A14 Cambridge to Huntingdon Improvement Scheme

IRSA3 SWAVESEY AND LAR LINK (SWAVESEY TO BAR HILL) RESPONSE REPORT

Client	Highways England
Project	A14 Cambridge to Huntingdon Improvement Scheme
Document title	Section 4 –Swavesey And Lar Link (Swavesey To Bar Hill) Interim Road Safety Audit Stage 3 Response Report
Project No.	HA528983
Copy No.	
Document reference	HA528983-ACJV-HGN-S4_IRSA3-RP-C-0003
PCF Stage

Problem 001

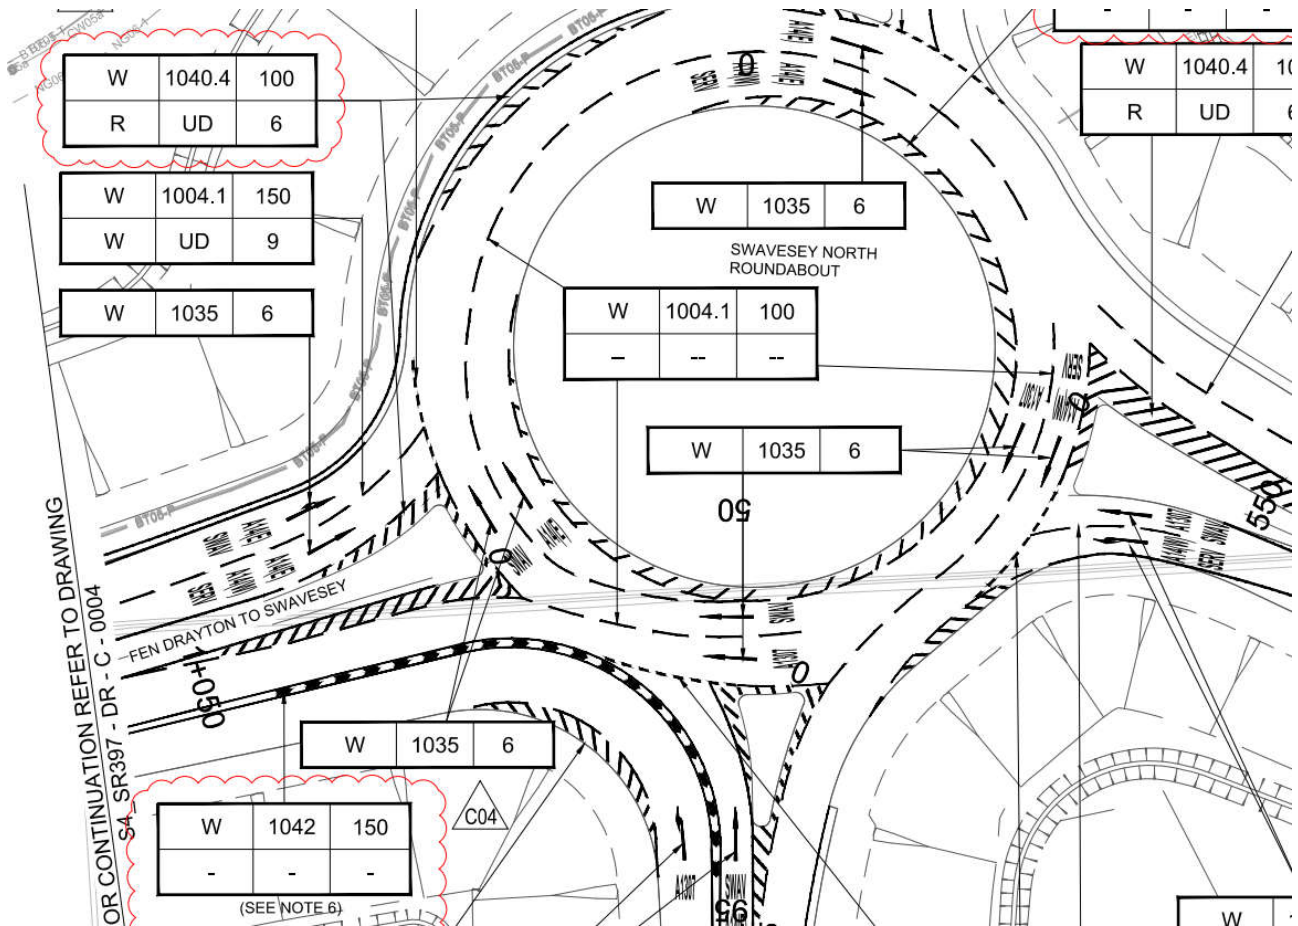
Location: A14 eastbound, Swavesey northern roundabout.

Summary: Lane markings on the entry arm approaches and circulatory carriageway markings may result in conflicts.

- 3.1. Vehicles turning right from the A14 Swavesey eastbound exit slip road, onto the LAR towards Swavesey and the Bucking Way roundabout would ordinarily be in Lane 2.
- 3.2. Similarly, vehicles turning right from Swavesey Link Road, west onto the A1307, would be in Lane 2 on the approach to the roundabout.
- 3.3. The Audit Team is of the opinion that the lane marking on the approaches and on the circulatory carriageway require motorists to change lanes in order to exit their intended destination.
- 3.4. This is likely to result in conflicts / side-swipe collisions on the roundabout.

- 3.5. It is recommended that the configuration of entry arm approach lanes and traffic lanes on the circulatory carriageway are reviewed and amended.

- 3.6. **Agreed** – The Designer has reviewed Drg No HA528983-ACJV-HMK-S4_SR397-DR-C-0005 - C04 [refer snapshot below] and is content there is no confusion in the configuration of road marking provision

3.7. Potentially this could be an incomplete installation. Construction details should be verified against the IFC information.

3.8. OO agree Designers Response - arrows and destination markings on the circulatory carriageway were missing at the time of audit - to be raised as DOWLS.

3.9. OO to raise DOWLS for incomplete items.

Problem 004

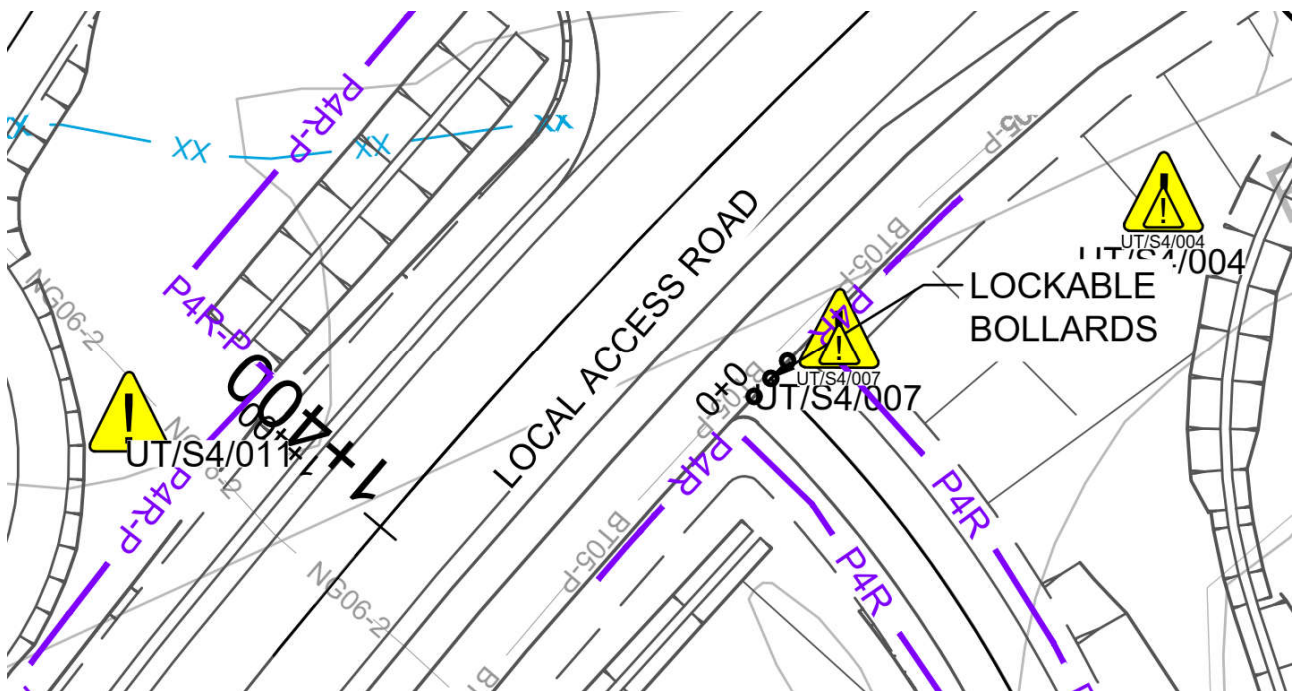
Location: LAR, northern side, approximate Ch.1+375

Summary: Risk of cycle conflicts with pedestrians and motor traffic.

- 3.24. The Swavesey NMU bridge has a continuation of the NMU route that descends towards the northern side of the LAR. There are no measures at the bottom of the ramp to mitigate speeds of cyclists.
- 3.25. This has the potential for cyclists to either exit rapidly onto the LAR, potentially conflicting with vehicles traversing along it, or to collide with pedestrians traversing along the NMU route on the northern side of the LAR.

- 3.26. It is recommended that measures are introduced to reduce cycle speeds on the descent from the NMU overbridge.

- 3.27. **Agreed** – The Designer agrees that measures to control cycle speeds on the ramp should be considered and implemented where considered appropriate.
- 3.28. The Designer notes that the AIP for the associated footbridge requires provision to be made for vehicular access; Drg No HA528983-ACJV-HFE-S4_SR397-DR-C-1007-C04 shows the proposals for lockable bollards [refer snapshot below].

- 3.30. Designer to determine provision of suitable measures to both manage cycle speeds AND allow vehicular access for maintenance to the footbridge.
